NEPAL ELECTRICITY AUTHORITY
Transmission Directorate
Grid Development Department
New Modi Lekhnath 132kV Transmission Line Project

Subject: Issuance of Clarification-1 and Addendum-1

Ref: Package ML2: Procurement of Plant Design, Supply and Installation of Laha Chowk 132 kV Substation, New Modi 132 kV Switching Station and 132 kV Line Bay expansion at Lekhnath Substation (IFB No: ML/SS/ /074/75- 1)

ADDENDUM-1

DWG NO.1

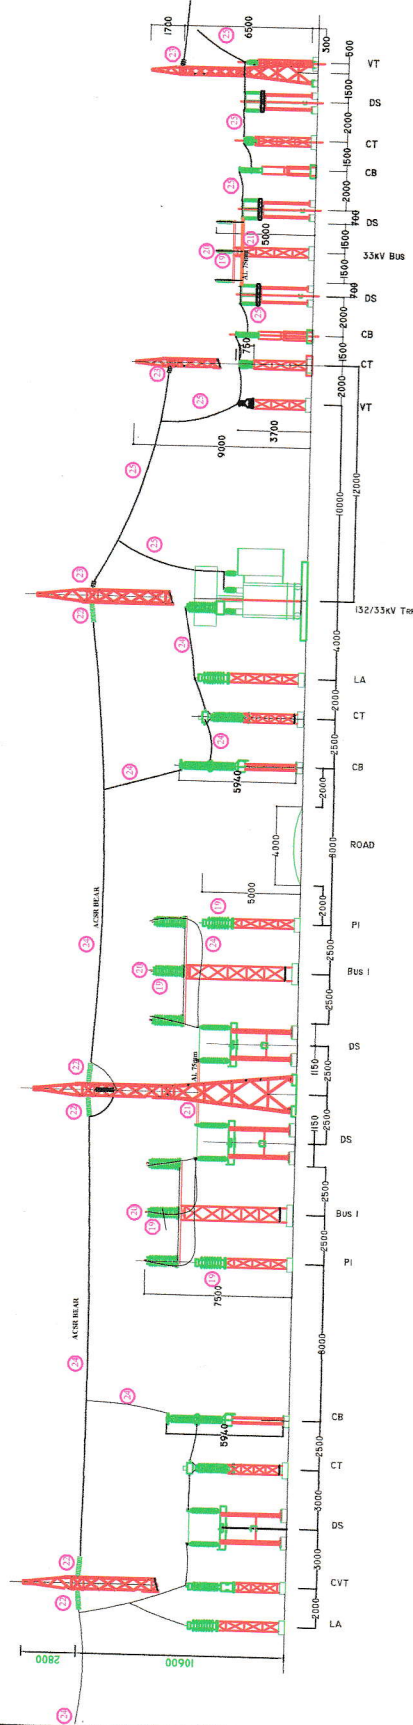
132kV LINE BAY, 132/33kV TRANSFORMER BAY & 33kV INCOMER SECTION

DWG NO.2

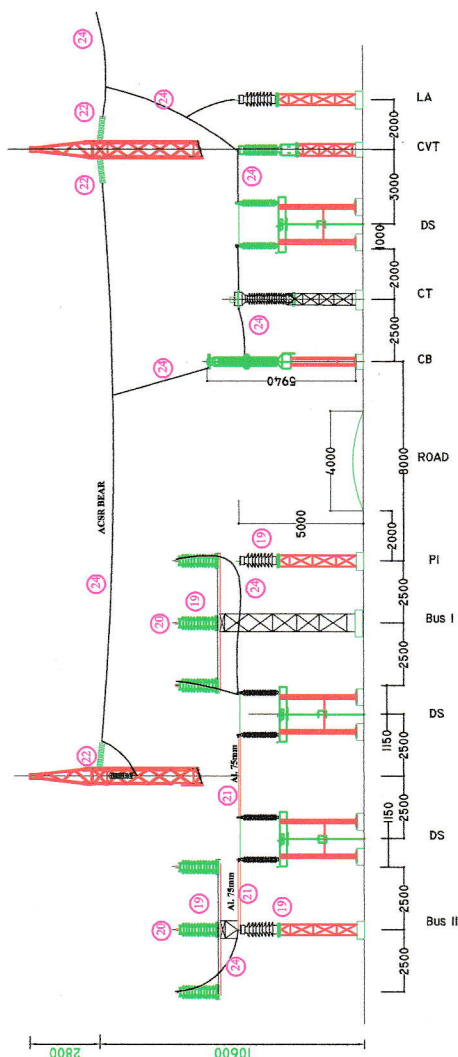
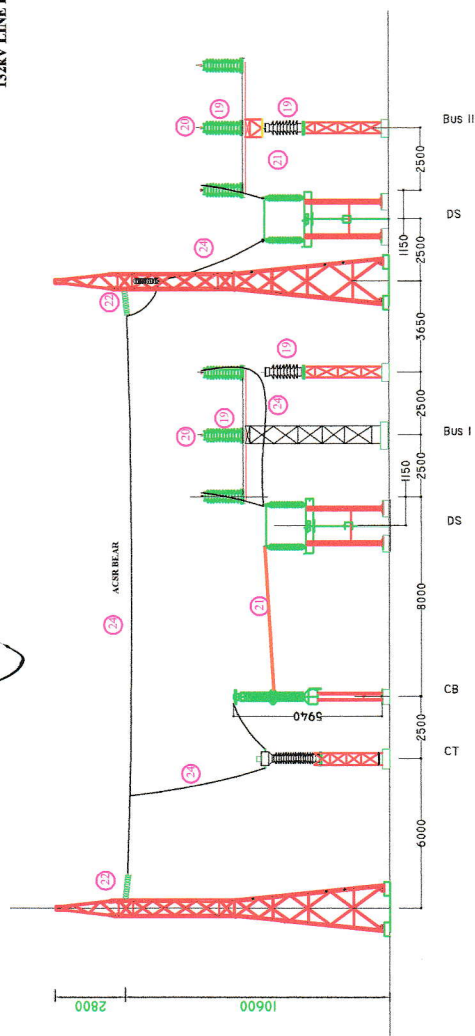
132kV LINE BAY SECTION

132kV BUS COUPLER BAY SECTION
